ADDENDUM 02

SB840 – Wiekamp Hall Replace Cooling Tower
Indiana University – South Bend
IU 20250610

Mussett, Nicholas & Associates, Inc.
502 S. West St
Indianapolis, IN 46225
MNA Commission No.: 2026023

M101

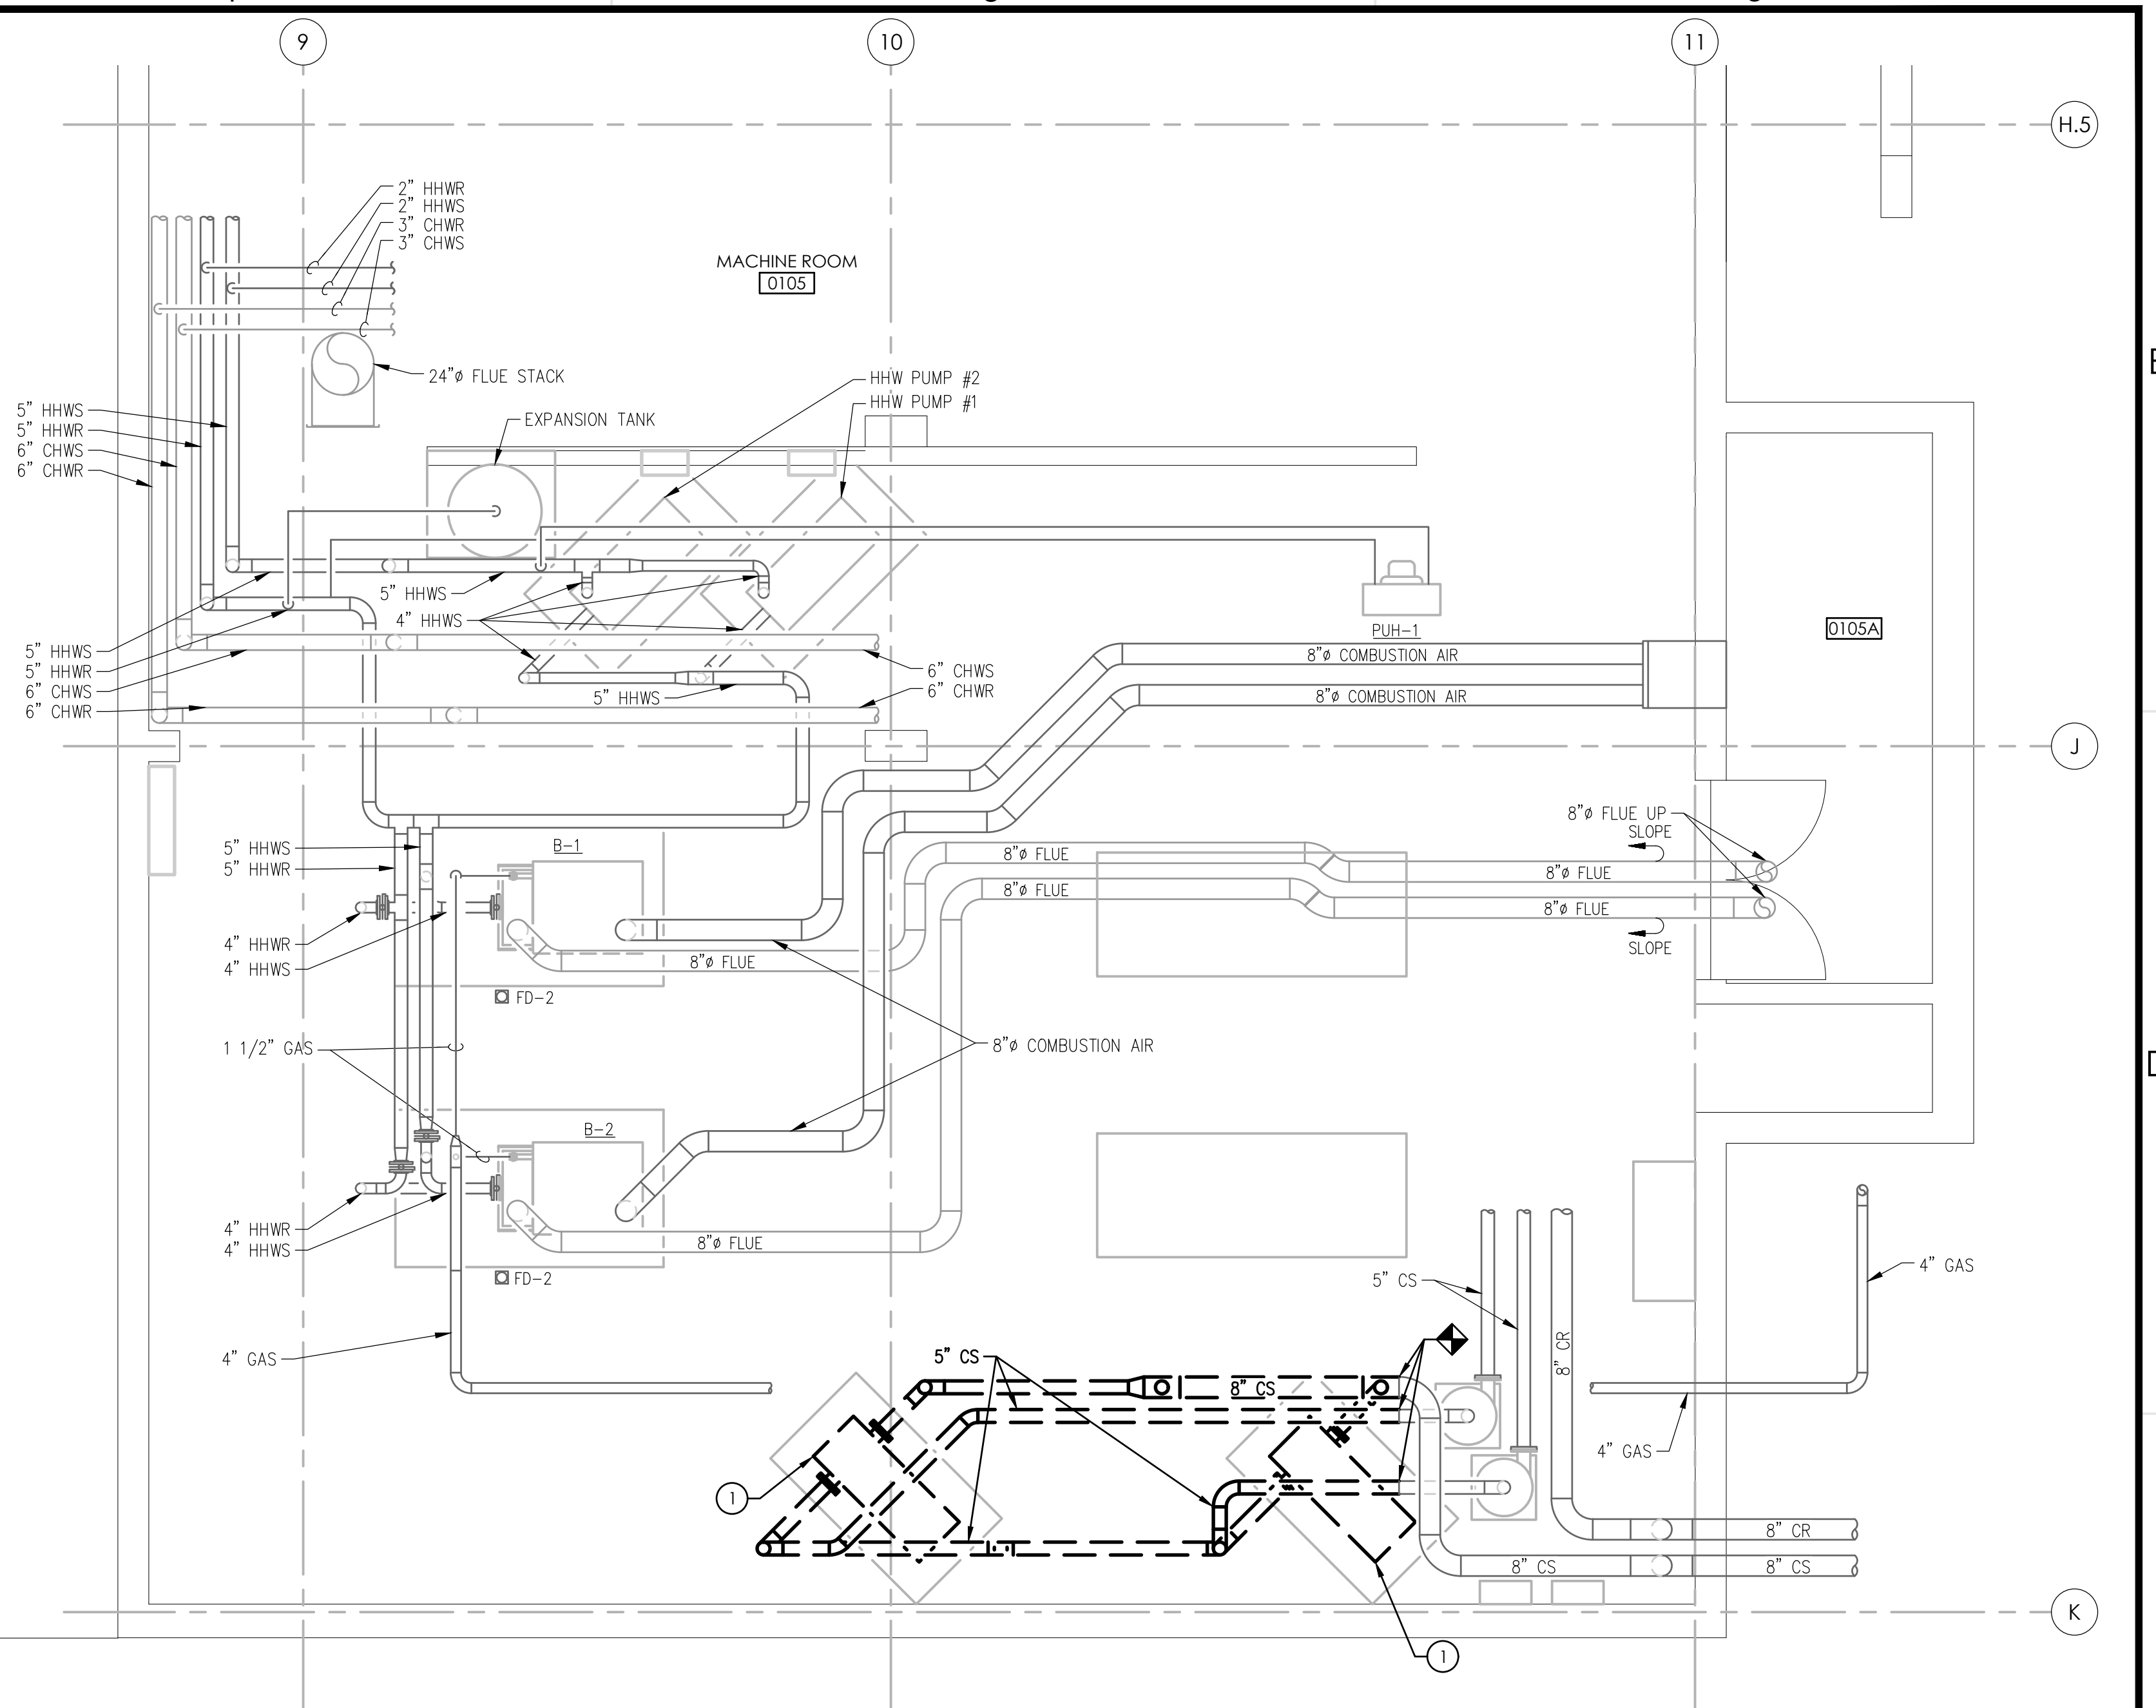
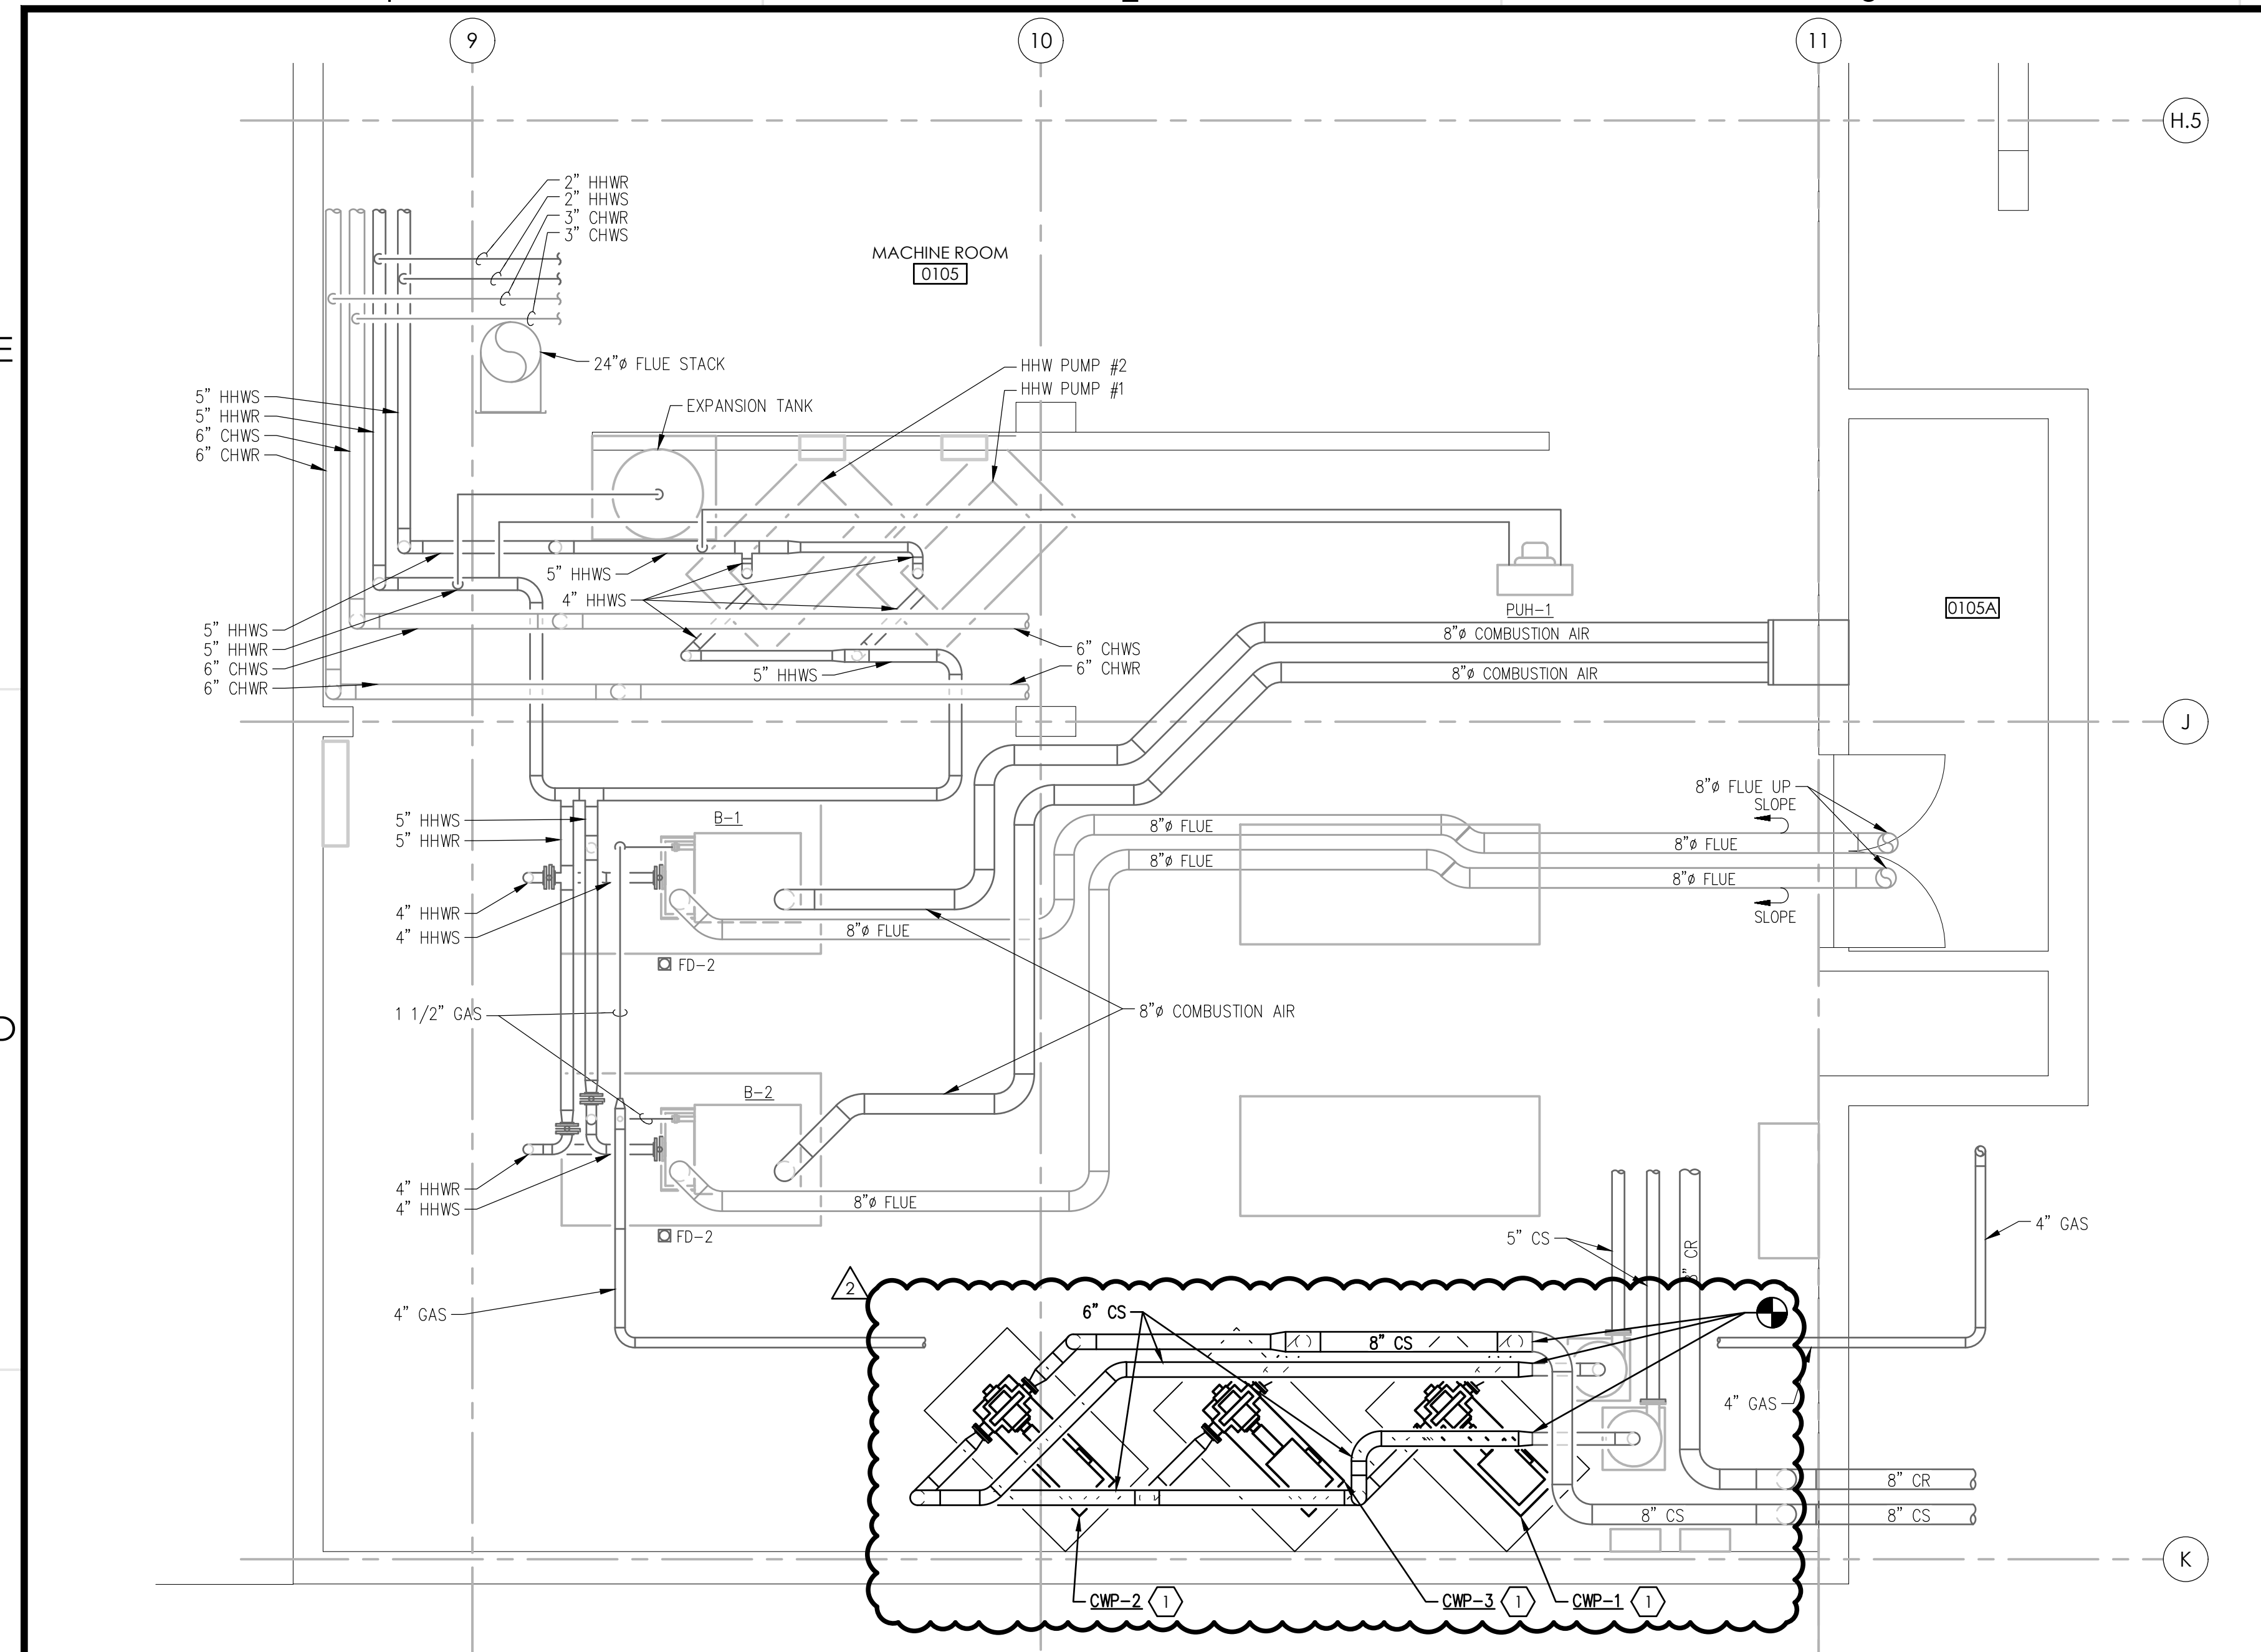
- A. Provide epoxy primer and paint on all interior/exterior condenser water piping. Match existing paint colors. Refer to Sheets M101 and M102 in this Addendum for clarification.

- Item No. 5 Please confirm schedule 40 PVC DWV is acceptable for the cooling tower drain piping.
- A. Confirmed.
- Item No. 6 Sheet M101 detail #1 indicates for existing inertia bases to be removed and concrete base to remain. Detail #2 note #1 indicates for a new inertia base to be installed on the existing concrete pad (two locations). There are no existing concrete housekeeping pads. Please clarify if we are to reuse the existing inertia bases or if we are to demo the existing bases and provide new concrete housekeeping pads and inertia bases.

Item No. 1 Sheet M101

- A. Added General Note G1.
- B. Revised Keyed Note #1.
- C. Removed Keyed Note #2.

- A. Refer to M101 in this Addendum for clarification. Provide concrete housekeeping pad and inertia base on all new pumps.

- REMOVE CONDENSER PUMP, INERTIA BASE, AND ASSOCIATED PIPING AND CONTROLS.

- PROVIDE EPOXY PRIMER AND PAINT ON ALL CONDENSER WATER PIPING. MATCH EXISTING PAINT COLORS.

- PROVIDE CONDENSER PUMP, INERTIA BASE, AND ASSOCIATED PIPING AND CONTROLS. PROVIDE 4" CONCRETE PAD. REFER TO DETAIL 'A' ON SHEET M601 FOR MORE INFORMATION.

E200

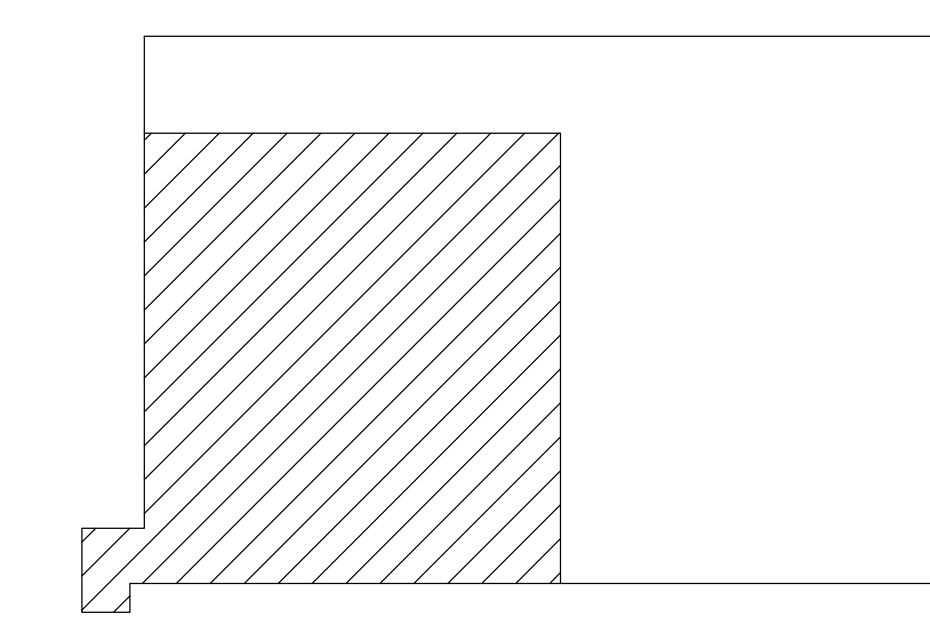
Item No. 3 Sheet E200

- A. Revised keyed notes.
- B. Added 120V connection to valves.

- 1. PROVIDE 100A, NEMA 3R FUSED DISCONNECT. PROVIDE 30A FUSES.
- 2. PROVIDE HEAT TRACING ON MAKEUP WATER LINE AND RECONNECT TO EXISTING SOURCE.
- 3. PROVIDE 7.5HP, NEMA 3R VFD. BASIS OF DESIGN IS ABB SERIES ACH580.
- 4. PROVIDE (2) #10, #10 GND IN EXISTING RACEWAY FROM PANEL 'RP-PS/29' FOR MOTOR HEATER. INTEGRATE WITH VFD PER THE MANUFACTURER INSTRUCTIONS. PROVIDE GFCI 20A/1P BREAKER IN POSITION 29.
- 5. PROVIDE CONDUCTORS BACK TO SOURCE. EXTEND CONDUIT TO NEW LOCATION.
- 6. PROVIDE (2) #10, #10GND IN 3/4" TO PANEL 'RP-PS/30' FOR 120V CONTROL VALVES. PROVIDE GFCI 20A/1P BREAKER IN POSITION 30.
